DOWNTOWNER COMMERCIAL PARK **SUBDIVISION, RESUBDIVISION OF LOTS 1 & 3**

APPLICATION NUMBER 5 DATE September 6, 2018
APPLICANT Downtownner Commercial Park Subdivision, Resubdivision of Lots 1 & 3
REQUEST Subdivision

DETAIL SITE PLAN

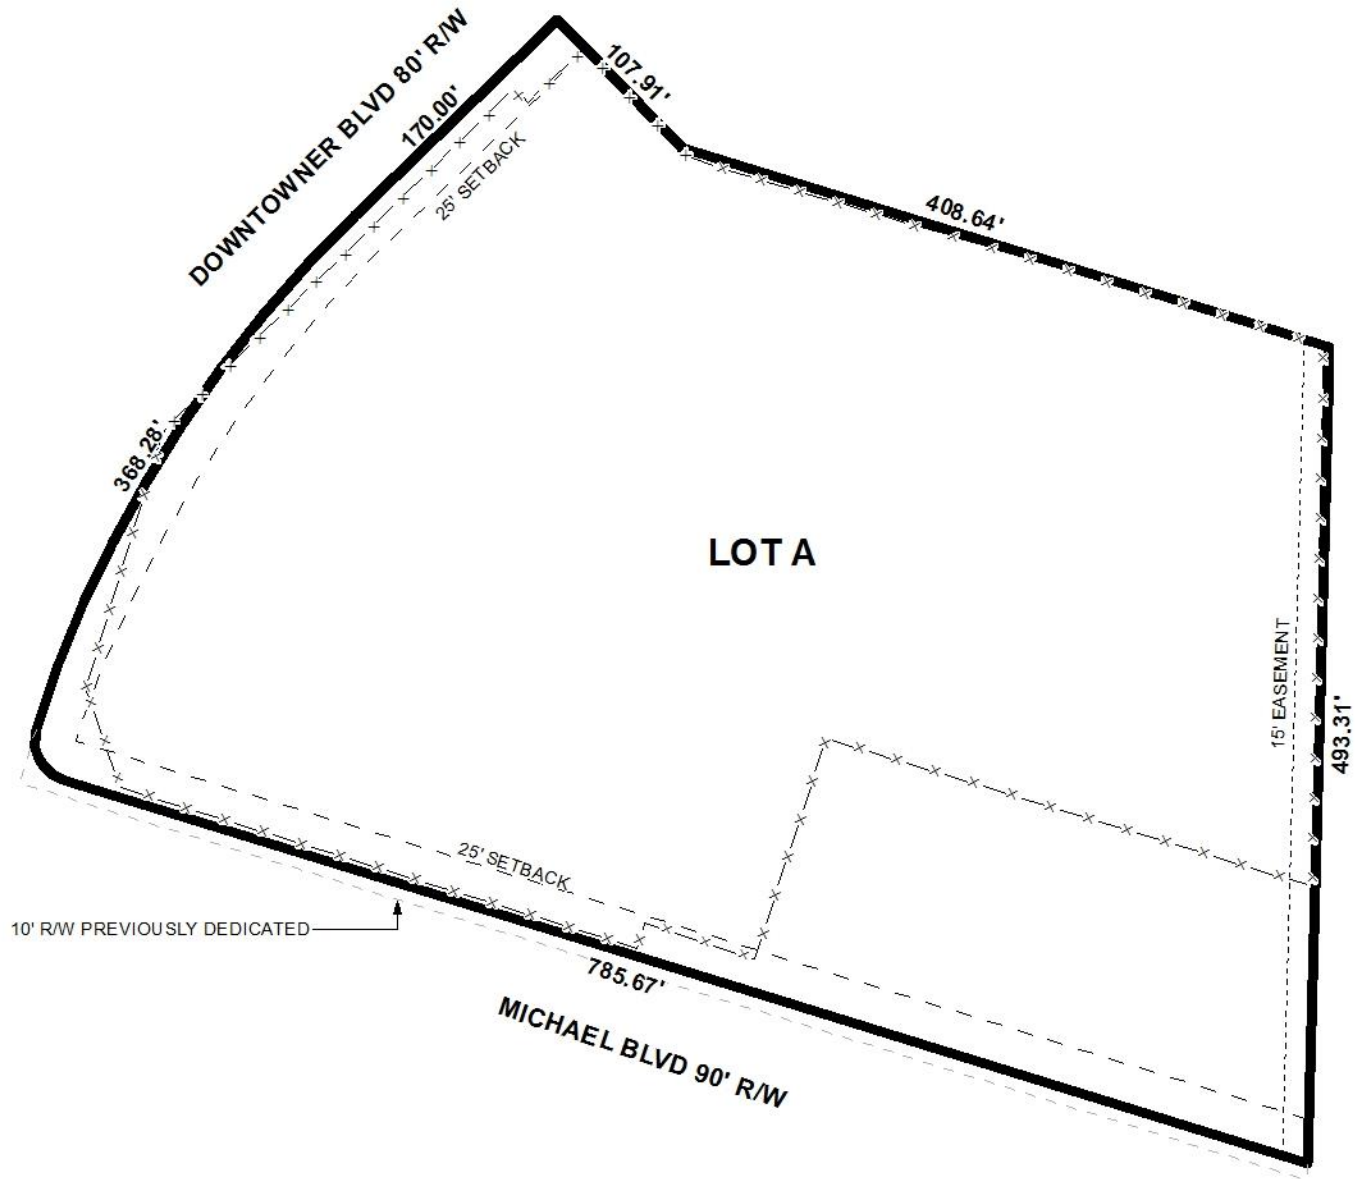
As on the preliminary plat, the lot size in both square feet and acres should be retained on the Final Plat, or a table should be furnished on the Final Plat providing the same information. The 25' minimum building setback line and the street right-of-way widths should also be retained on the Final Plat. The plat indicates a 15' drainage easement along the East boundary of the site. Therefore, a note should be required on the Final Plat stating that no structure may be constructed or placed within any easement.

Lot 1 was developed with a public sidewalk within the right-of-way. If approved, this application will expand the site to include an undeveloped area with no public sidewalk within the right-of-way. Therefore, the applicant should be mindful that, when developed, a public sidewalk will be required to be constructed along the new portion of the lot along Michael Boulevard, or a Sidewalk Waiver must be granted.

- 1) placement of a note on the Final Plat stating that the lot is limited to its existing curb cuts with any changes in size, location and design to be approved by Traffic Engineering and conform to AASHTO standards;

- 2) retention of the lot size label in both square feet and acres on the Final Plat, or the furnishing of a table on the Final Plat providing the same information;

- 3) retention of the 25' minimum building setback line along both street frontages on the Final Plat;
- 4) retention of the right-of-way widths for both streets on the Final Plat;

- 5) placement of a note on the Final Plat stating that no structure may be constructed or placed within any easement;
- 6) compliance with the Engineering comments: *[FINAL PLAT COMMENTS (should be addressed prior to submitting the FINAL PLAT for review and/or signature by the City Engineer): A. Provide all of the required information on the SUBDIVISION PLAT (i.e. signature blocks, signatures, certification statements, written legal description, required notes, legend, scale, bearings and distances) that is required by the current Alabama State Board of Licensure for Professional Engineers and Land Surveyors. B. Provide and label the monument set or found at each subdivision corner. C. Add a signature block for the Owner, Notary Public, Planning Commission, Surveyor, Traffic Engineer, and City Engineer. D. Provide the Surveyor's, Owner's (notarized), Planning Commission, and Traffic Engineering signatures. E. Add a note to the SUBDIVISION PLAT stating that a Land Disturbance permit will be required for any land disturbing activity in accordance with Mobile City Code, Chapter 17, Storm Water Management and Flood Control); the City of Mobile, Alabama Flood Plain Management Plan (1984);*
